Washington Park

Washington Park is a medium/large neighborhood park that provides parking, a playground, barrier and walkways. The main issues at this park are slopes being too steep, no accessible picnic tables, no accessible benches and protruding branches. **Please Note:** When a **UD** is indicated, this is a Universal Design (**UD**) recommendation to enhance accessibility. The **UD** recommendation is not required to meet the minimum accessibility standards but it would be encouraged.

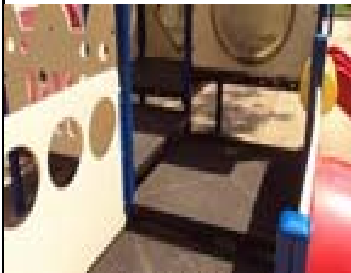
Photo	Barrier	ADAAG/IAC	Solution	Priority	By Whom	Projected Cost	Projected Date	Action Taken
	The portable toilet has a hand sanitizer mounted to high at 55 1/2" AFF.	ADAAG 604.7	When ordering the rental of the portable accessible toilets, make sure the company provides the proper heights, and element sizes in their accessible portable toilets. The toilet should paper dispenser to be no lower than 15", no higher than 48" AFF and a minimum of 7" to a maximum of 9" in front of the toilet. Do not			NA	2012	As Part of porta potty contract all rent facilities meet the standards. 4/2012
	The portable toilet provided has a toilet paper dispenser mounted to high at 55 1/2" AFF.	ADAAG 308	mount the toilet paper dispenser behind the side grab bar. The hand sanitizer should be provided in a reach range no higher than 48" AFF for a forward reach over an obstruction no deeper than 20" or a side reach of 48" AFF over an object no deeper than 10". Provide a rear grab bar a minimum of 36" long mounted 12"			NA	2012	As Part of porta potty contract all rent facilities meet the standards. 4/2012

The grab bars are only 2' long.	ADAAG 604.5	from the centerline of the toilet to the corner and 24" from the centerline to the open side of the toilet. Also, provide a side grab bar a minimum of 42" long and a maximum of 12" from the corner. Both grab bars should be			\$500	2012	As Part of porta potty contract all rent facilities meet the standards. 4/2012

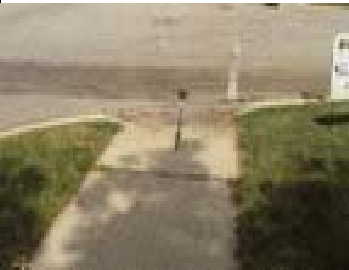
Photo	Barrier	ADAAG/IAC	Solution	Priority	By Whom	Projected Cost	Projected Date	Action Taken
	A picnic area with a grill is provided but there is only one accessible grill.	<p><u>Proposed</u> Outdoor Developed Areas Guidelines ADAAG 1011.5</p>	<p>Grill Recommendation: Follow Outdoor Developed Area Report that states 20% of grills, but at least two, be of accessible design, and connected to an accessible route. In this case provide one more accessible grill. The accessible grill should provide a cooking surface a minimum of 15" to 34" maximum AFF above the ground surface, a clear floor space and controls that are within a maximum reach range of 48" AFF. And a 48" by 48" space centered on the usable sides of the grill is required.</p>					Do not need two grills
	Behind Field #1 are branches that protrude into the walkway at 59" AFF.	ADAAG 307	Trim the branch to provide an 80" minimum clear head space and back to the edge of the walkway.

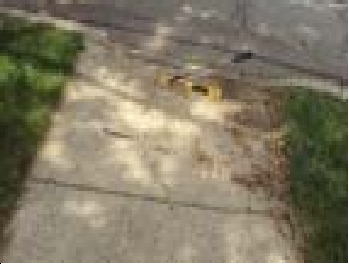
Photo	Barrier	ADAAG/IAC	Solution	Priority	By Whom	Projected Cost	Projected Date	Action Taken
Public Sidewalks and Their Issues at Washington Park								
	The sidewalk on the Westside of the park from the southwest corner up to the fire hydrant has a cross slope too steep at 2.6% to 9.0% for 167'.	ADAAG 403.3	Attempt a "mud jacking" technique or remove and regrade section to provide a cross slope no greater than 2%.			\$10,000		Staff will work with City as part of sidewalk replace program
	The sidewalk on the Westside of the park from near the fire hydrant to the parking lot driveway has a cross slope too steep at 2.6% to 4.1% for 65'.	ADAAG 403.3	Attempt a "mud jacking" technique or remove and regrade section to provide a cross slope no greater than 2%.			\$3,900		Staff will work with City as part of sidewalk replace program
	The sidewalk north of the drive at the dog fecal bags dispenser and basketball fence has a cross slope too steep at 2.6% to 4.9% for 71'.	ADAAG 403.3	Attempt a "mud jacking" technique or remove and regrade section to provide a cross slope no greater than 2%.			\$4,260		Staff will work with City as part of sidewalk replace program

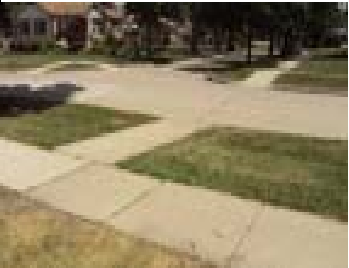
The north sidewalk near the northeast corner has a cross slope too steep at 2.6% to 3.9% for 62'.	ADAAG 403.3	Attempt a "mud jacking" technique or remove and regrade section to provide a cross slope no greater than 2%.			\$3,720		Staff will work with City as part of sidewalk replace program
